Service Bulletin

Bulletin No.: 18-NA-246

Subject: Malfunction Indicator Lamp (MIL) Illuminated - DTC P0172, P06DE and/or P0521 Set (North America Vehicles Only)

Note: The graphic above compares the old style primary PCV valve (A) to the **new** revised PCV valve (B).

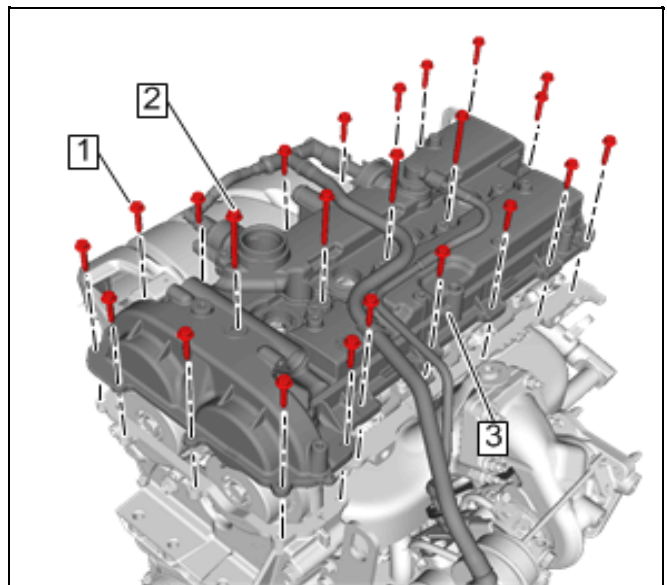
1. Remove the camshaft cover (3). Refer to *Camshaft Cover Replacement* in SI.
2. Remove the old style PCV valve from the cover and **discard**.
3. Apply a light coating of oil to the **new** revised PCV valve O-ring.

4. Using hand pressure, install the **new** PCV valve into the cover until seated into bore.
5. Install the camshaft cover.
